Project: FLORENCE COUNTY EMS
[BID NO. 31-14/15]

Addendum No.: ONE

Date: June 10, 2015

9000AGS VEHICULAR SLIDE GATE OPERATOR

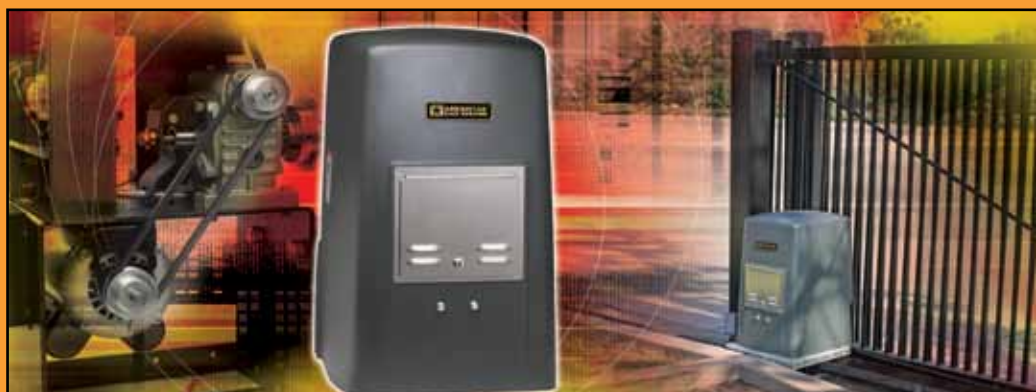
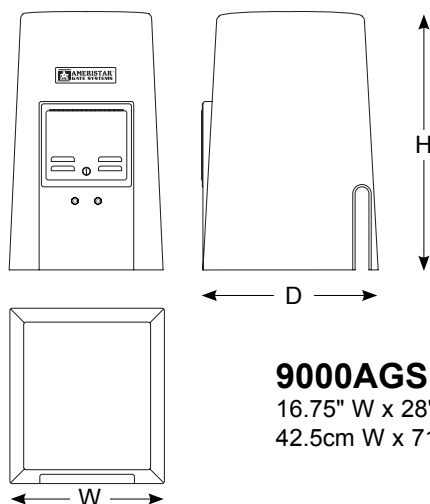
- b. Section 2.2, Fabric, subparagraph C, Steel Fabric:
 - 1). Size: 2 inch mesh
 - c. See attached for Slide Gate Operator
 - 1). Ameristar Gate Systems, 9000 AGS (½ hp)

SLIDE GATE OPERATORS

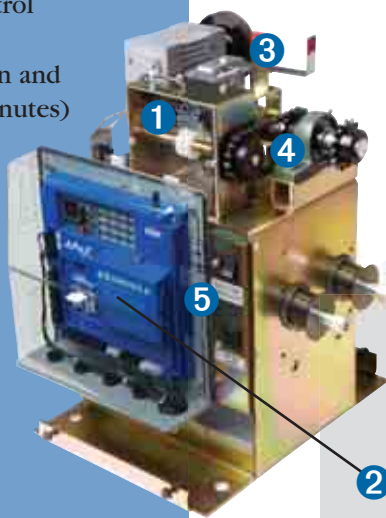
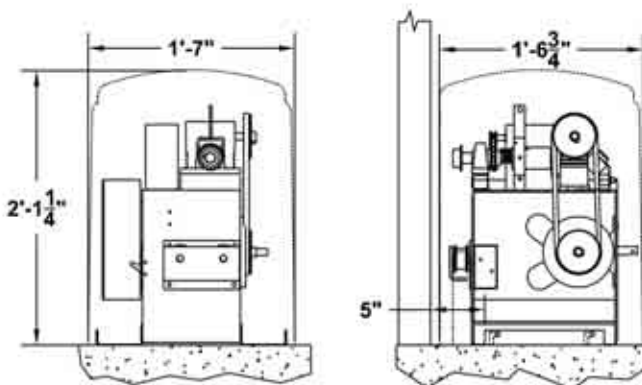
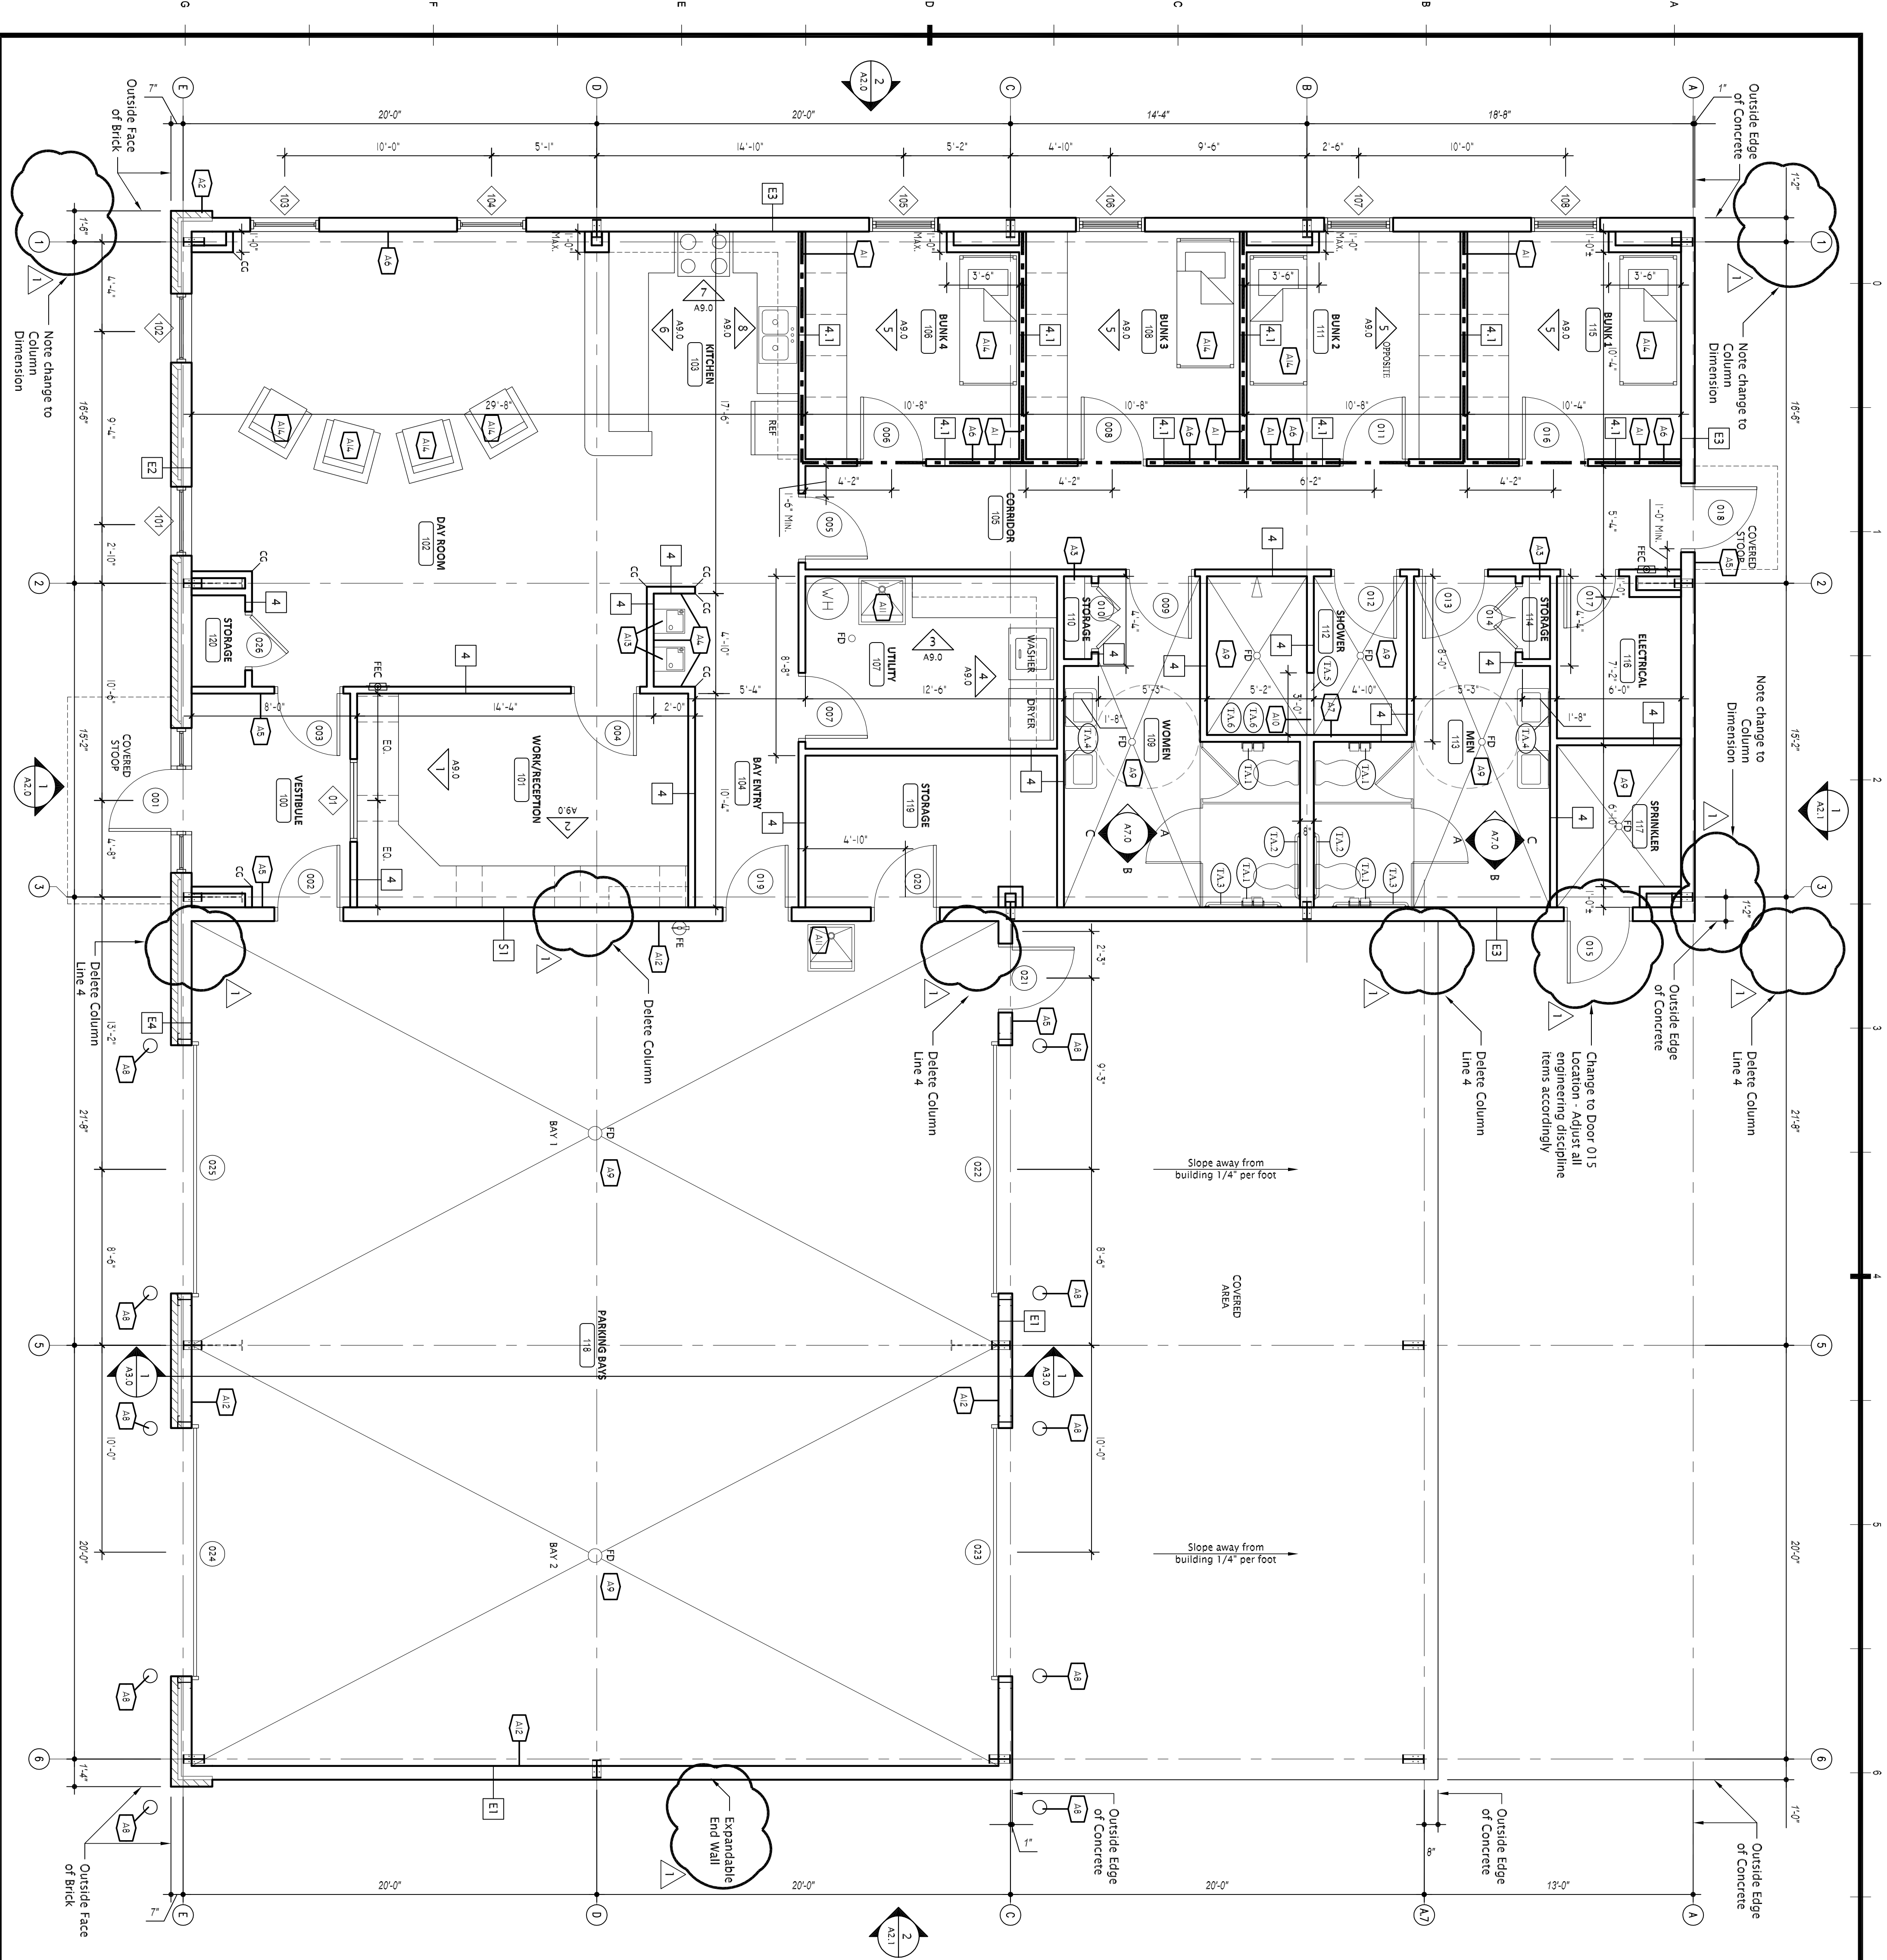
- 2). Linear, SLC-2 (½ hp)
 - 3). Others as approved by architect.
2. Refer to Floor Plan and Wall Sections.
 - a. Provide expansion material and caulk where building slab and exterior concrete abut.
